## Addendum #1

Re: **Addendum No. 1**  
Cary Main EMS  
819 Kildaire Farm Road  
Cary, NC 27511  
ADW Job No. 21046  
Wake County Bid #24-086

These clarifications constitute Addendum No. 1 and considered part of the Bid Documents. General Contractor shall see that their sub-contractors are in full receipt of the information contained herein.

P300

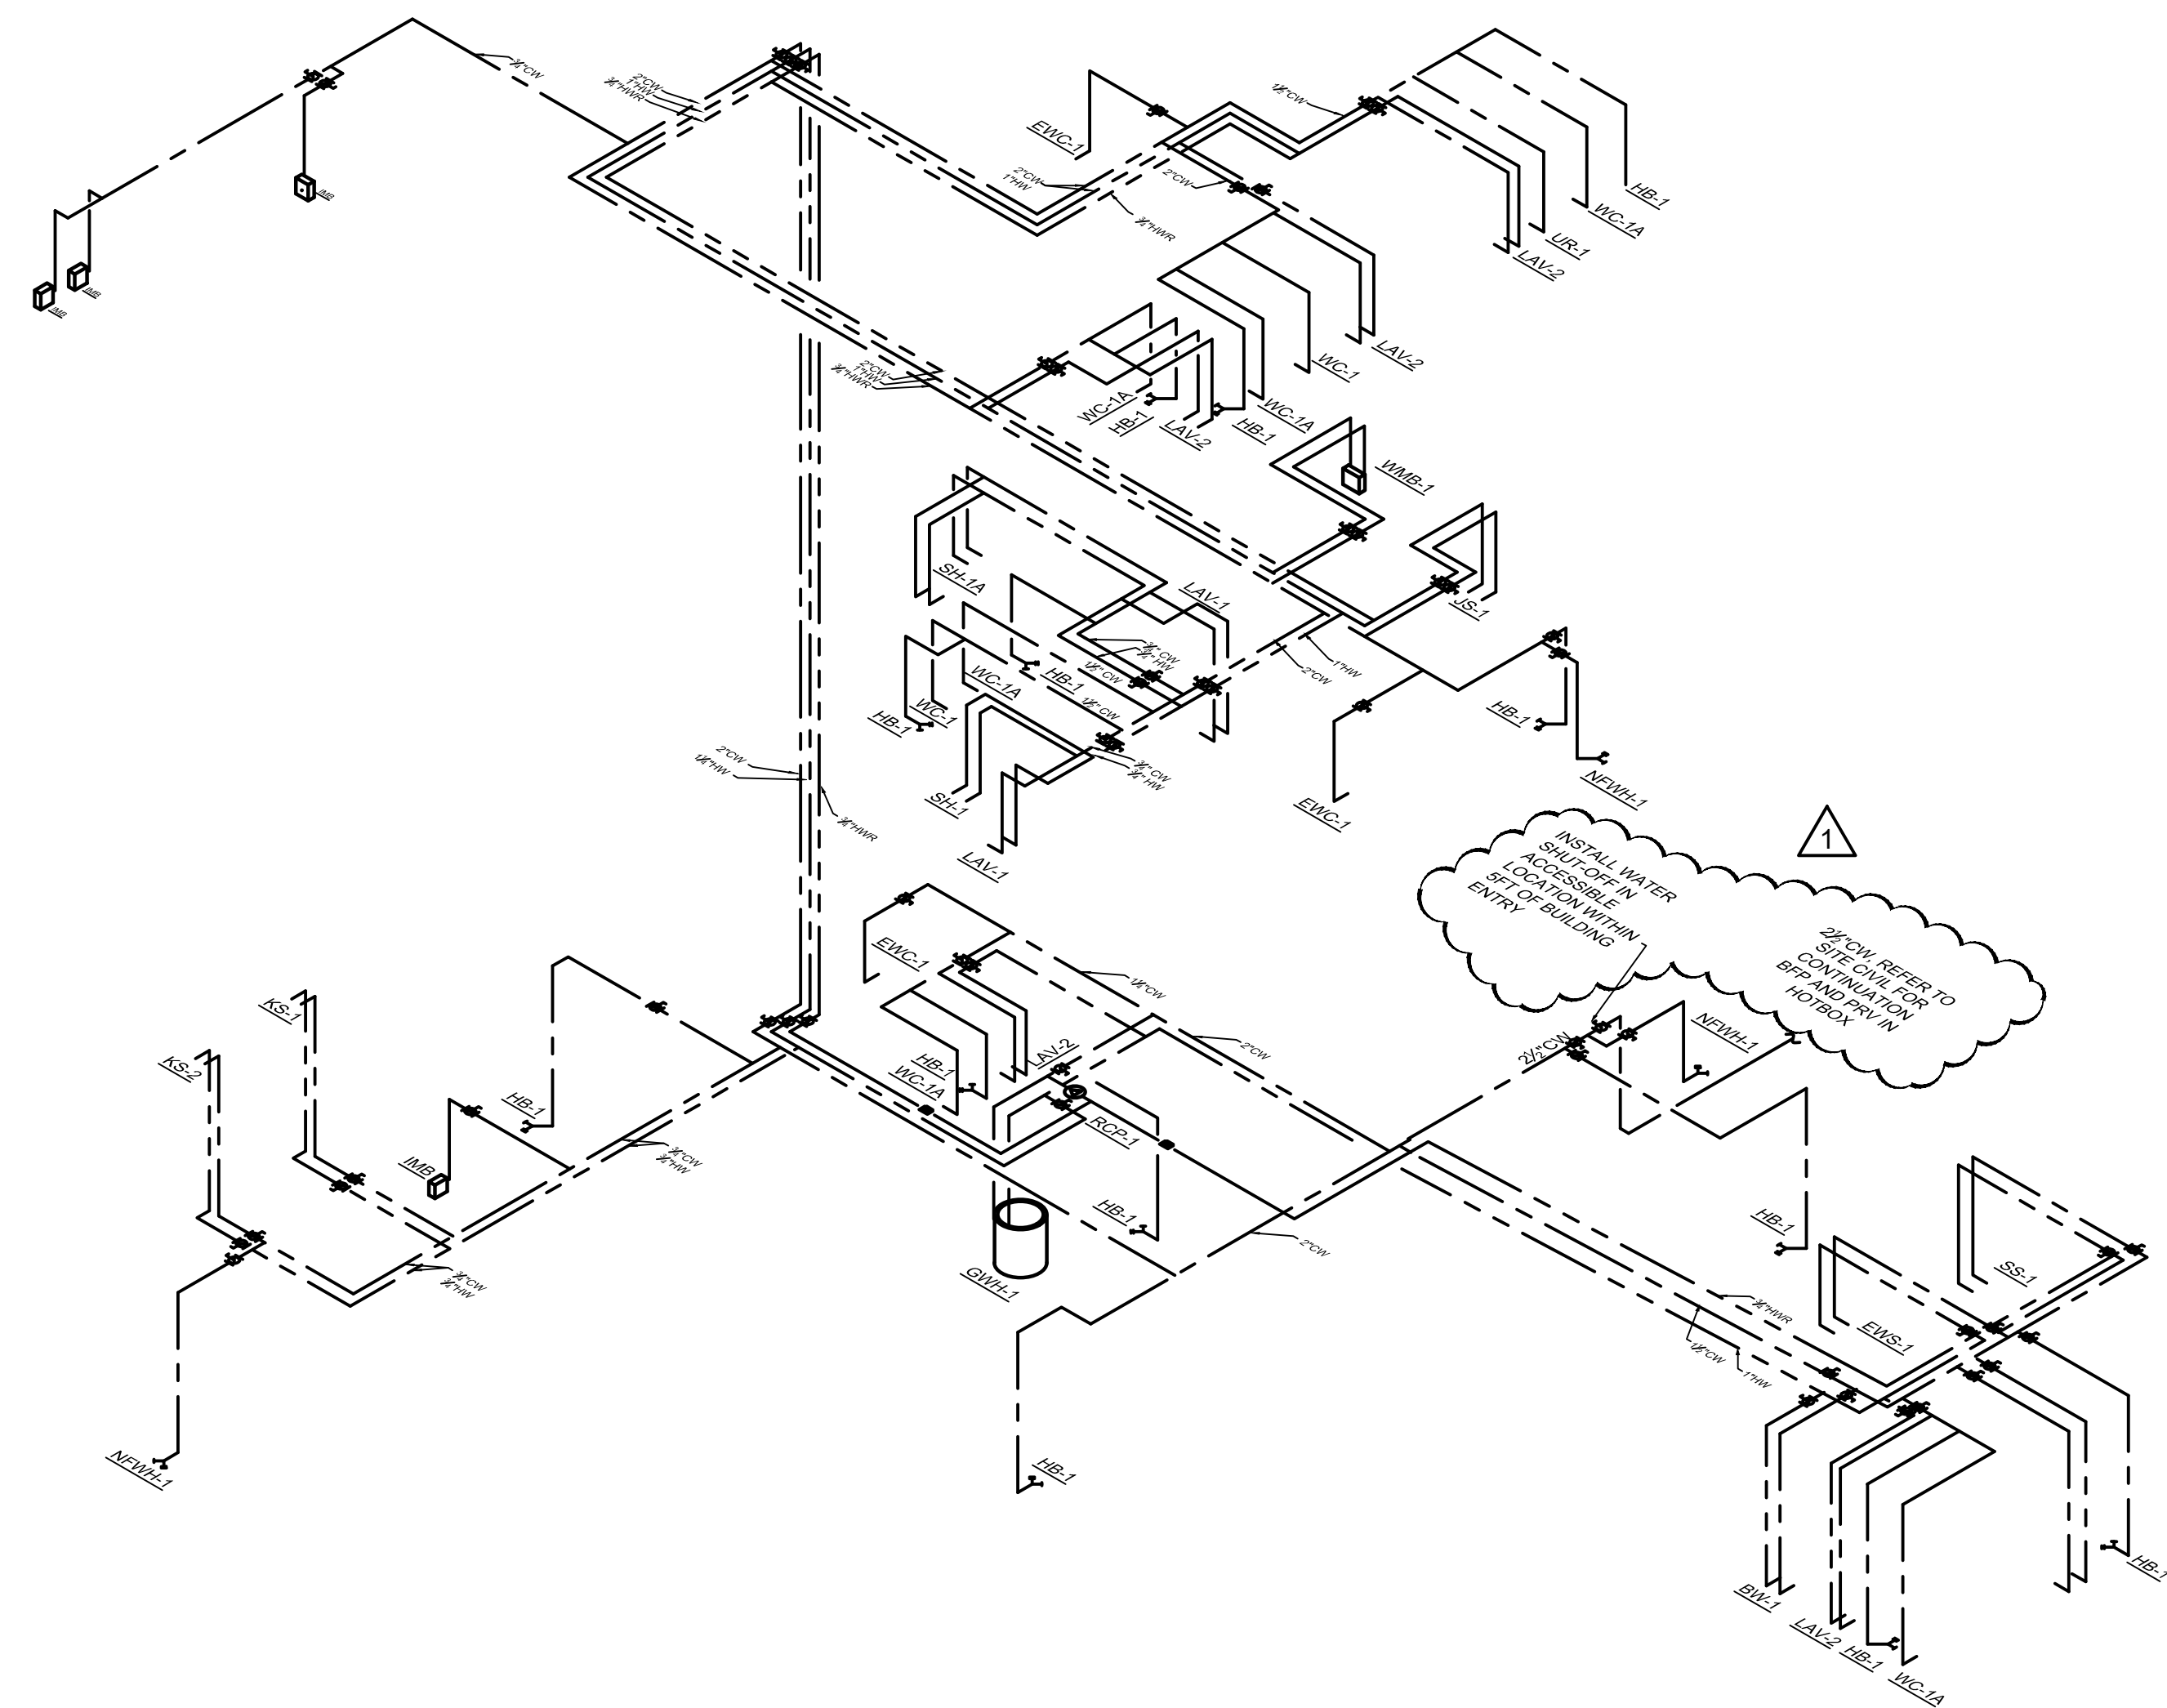
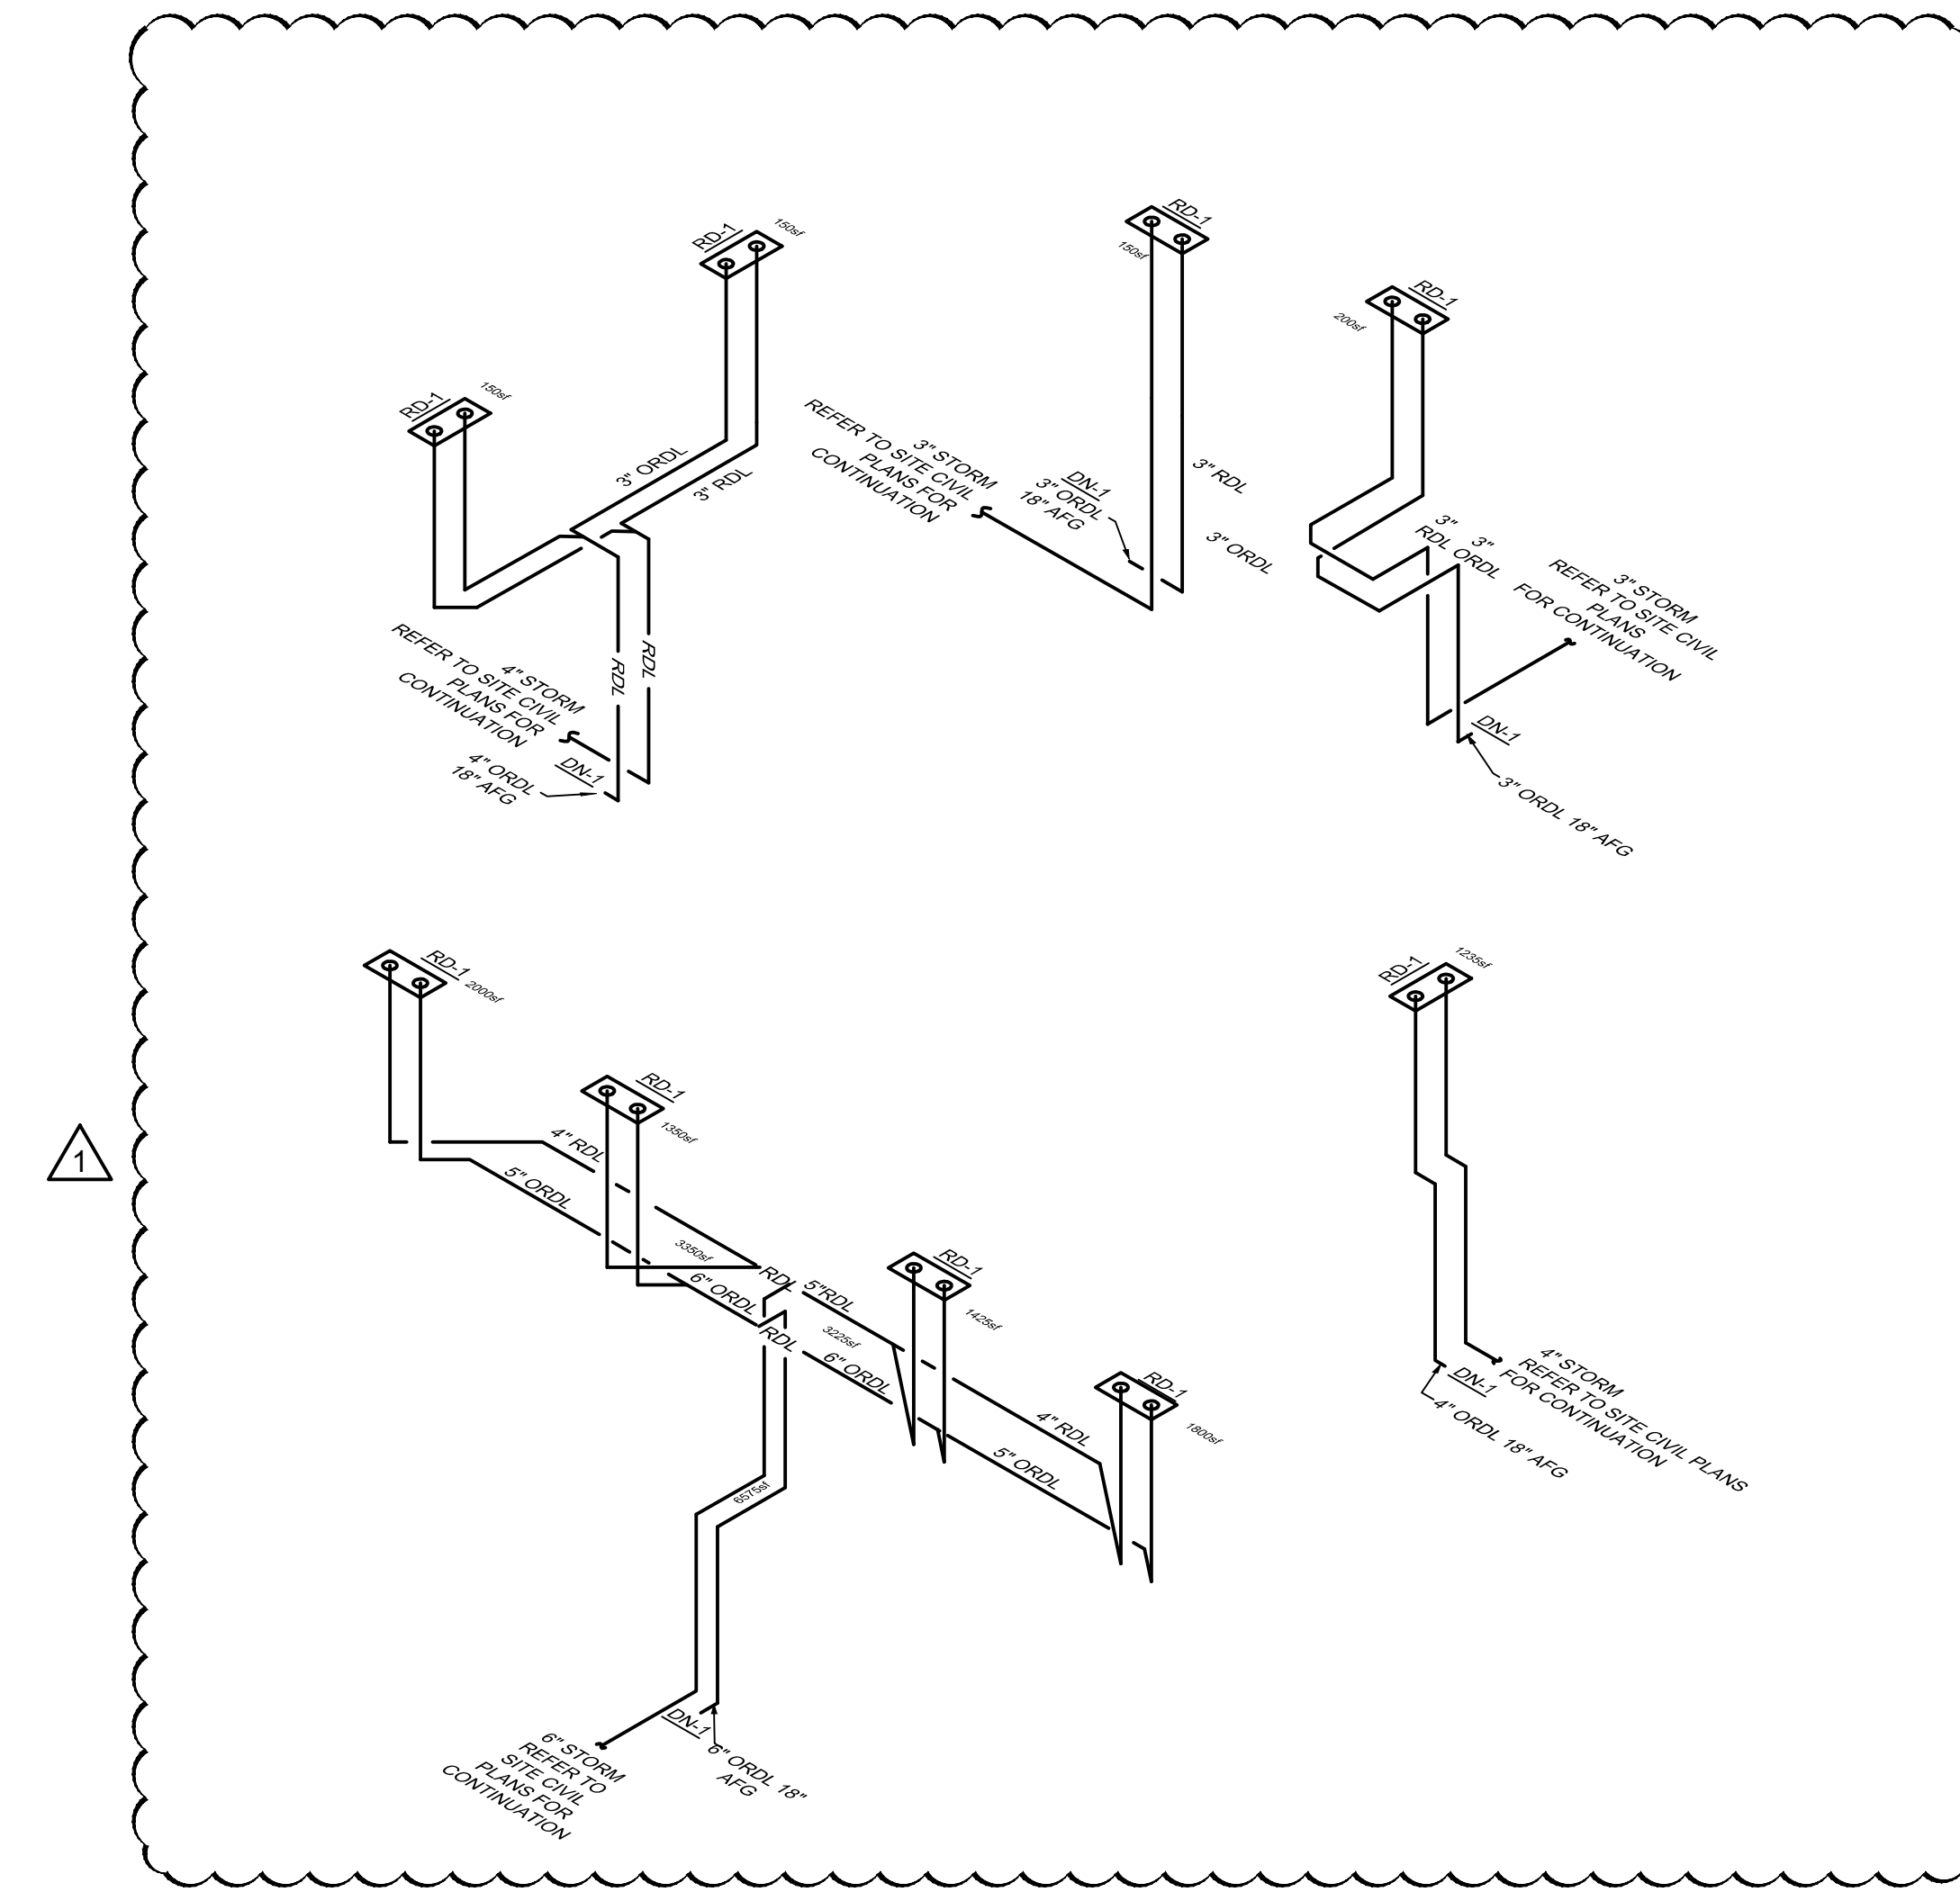
- 1.) Sheet P001: See attached revised sheet for gas load summary per permit comments.
- 2.) Sheet P201: See attached revised sheet for note regarding incoming water service, back flow preventer and PRV valve per permit comment.
- 3.) Sheet P210: See attached revised sheet for revisions to LAV-2 in Men 206. Roof square footage added to low roof area per permit comment.
- 4.) Sheet P200: See attached revised sheet for roof area drainage square feet per permit comment.
- 5.) Sheet P301: See attached revised sheet for updates to the riser diagrams per permit comment.
